**To:** Russell Butchers, Auckland Council  
cc/- Drury Metropolitan Centre Consolidated Stages 1 and 2 Expert Panel

**From:** Mary Wong / Pamela Santos – Barker & Associates Limited

**Date:** 24 July 2025

**Re:** Response s67 further information memorandum recommended by Auckland Council

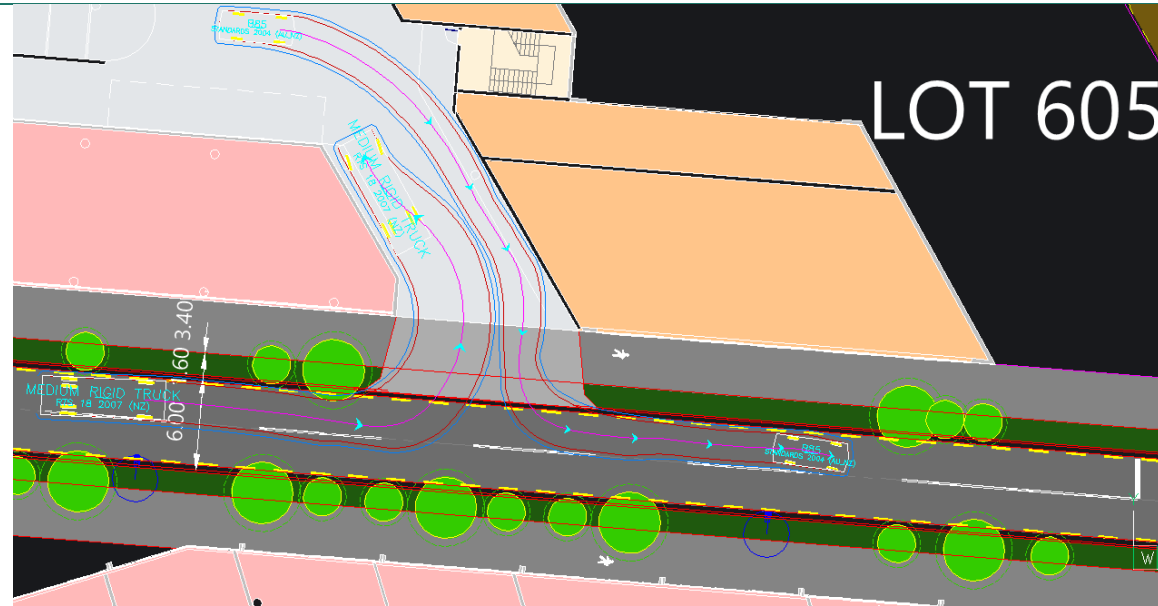
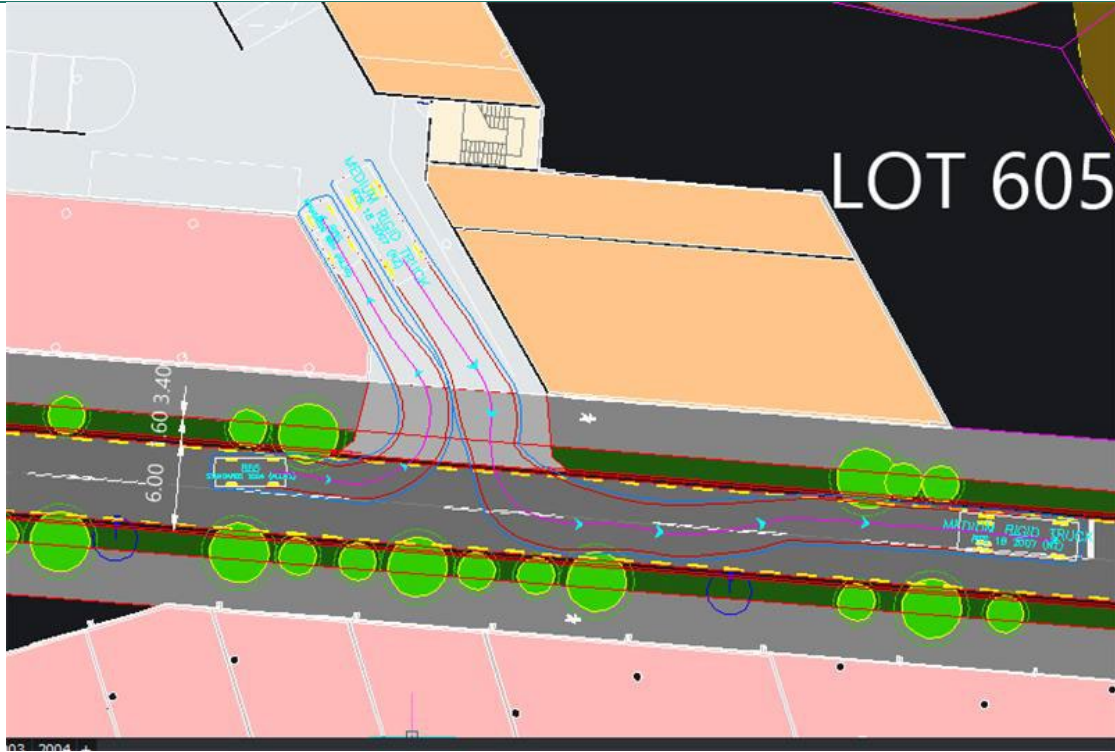
53	<p>Stage 2 – Lot E</p> <p>Table 7 of the ITA states that informal loading is anticipated to occur in the eastern car park, and that a formal loading space is provided in the western car park. Figure 48 of the ITA an 8m truck entering the eastern car park, however vehicle tracking is not provided for the western car park. The vehicle tracking for the eastern car park shows potential conflict with columns and informal loading may conflict with other vehicle movements, and it is unclear whether the truck can safely access the loading</p>	<p>Updated vehicle tracking analysis has been undertaken and demonstrates that loading can be undertaken safely and efficiently within the western car parking building. The vehicle tracking is undertaken using an 8.0m truck and is shown below.</p>

Figure 54 of the ITA an 8m truck entering the parking level, and Table 7 of the ITA states that loading is anticipated to occur parking level. The vehicle tracking shows conflict with opposing vehicle movements, and it is unclear whether the truck can safely access the loading space shown on Ignite Drawing GS-1302. We consider this may affect the safe and efficient operation of the site and adjacent transport network. We recommend that the applicant confirm how practical loading and servicing can be provided.

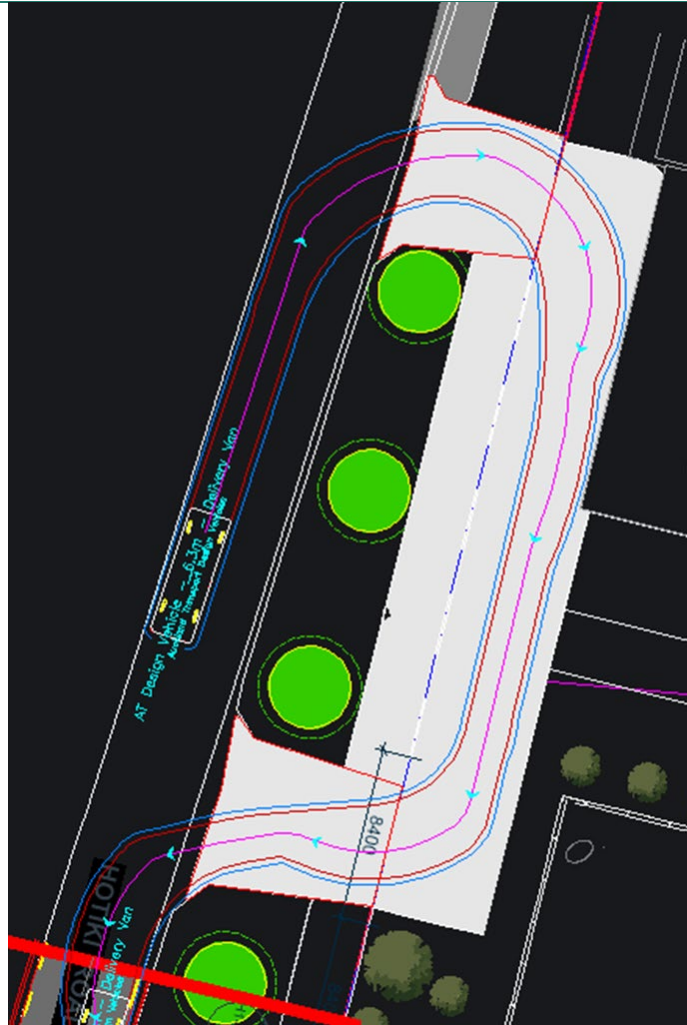
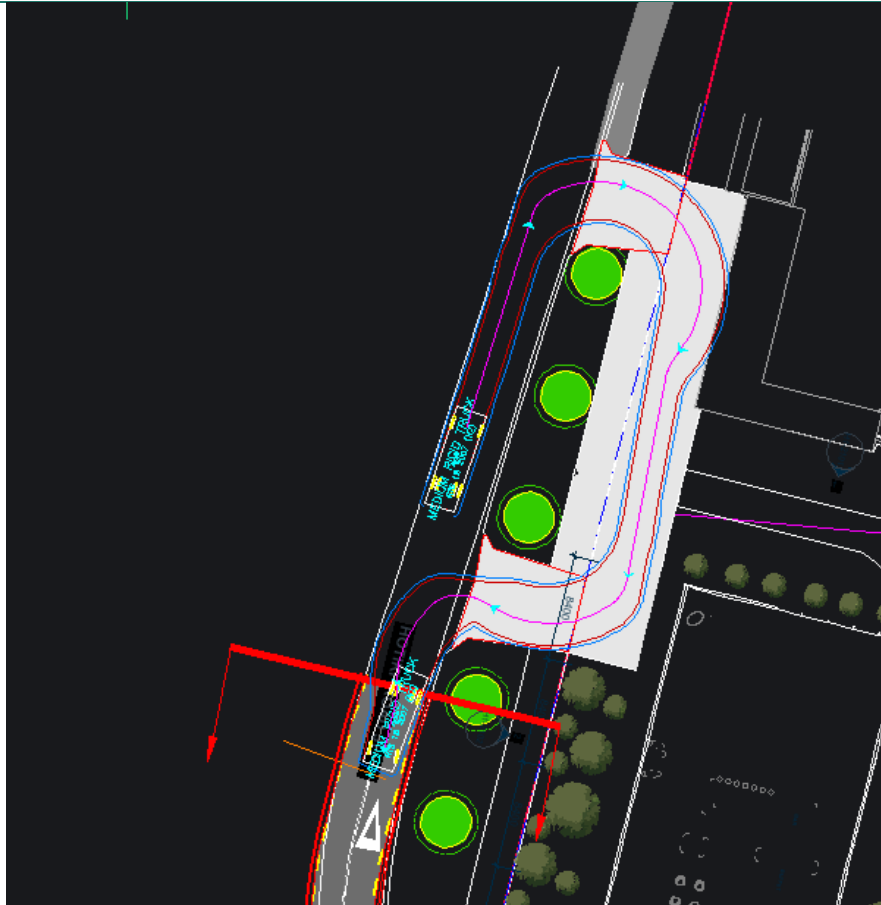
56	<p>Stage 2 – Lot H1</p> <p>Figure 55 of the ITA shows a loading space will be provided on Road 3 adjacent to Lot H1; however, this loading space is not shown on Woods Drawing 2004-DR. We recommend that the applicant confirm how</p>	<p>The proposed loading space has been reviewed and amended to that presented in the application. A new one-way loading zone is proposed in private land between H1 and H2, utilising the proposed H1 vehicle crossing for the entry, and the exit in front of H2.</p> <p>Vehicle tracking for a delivery van and an 8m truck provided below:</p>

practical loading and servicing can be provided.

It is noted that the current 8m truck tracking requires further refinement however, this will be resolved in detailed design / building consent. A condition of consent will be accepted that ensures that redesign will occur at the appropriate design stage.
